Professor Ian Acworth

Independent Monitoring Committee – Community Liaison Committee

Task 12 - Provide comment on the progress of the Botany Groundwater Cleanup Project to date

Task 5 - Botany Aquifer Levels – showing the development of a cone of depression due to over pumping and the recovery that occurred when pumping was stopped.

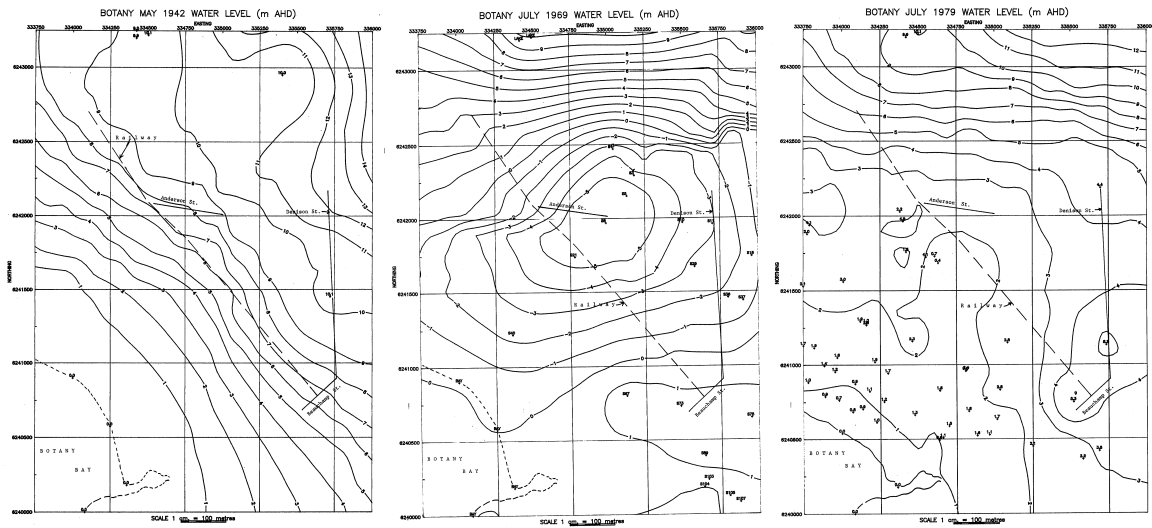
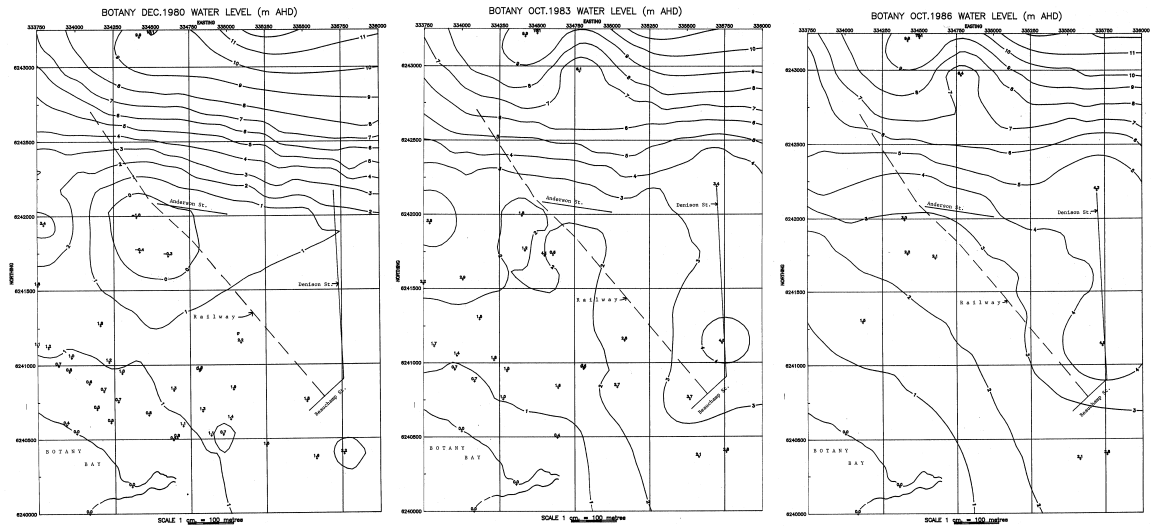
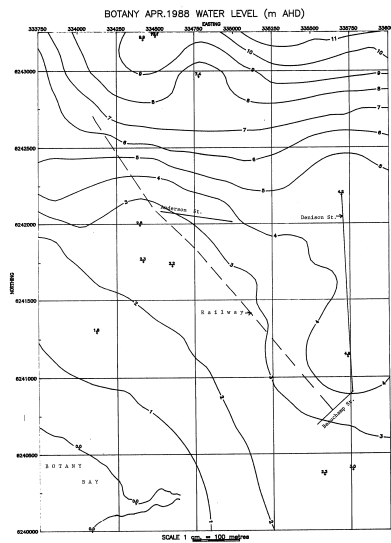
The GTP project is expected to have a significant impact on groundwater flows in the lower part of the Botany Sands Aquifer. The heads in the upper part of the aquifer could also be impacted by the long term abstraction that is now underway. The CLC should be requesting detailed information as to how the aquifer as a whole will be impacted.

The water abstracted from the aquifer represents a considerable resource. What will happen to this water?
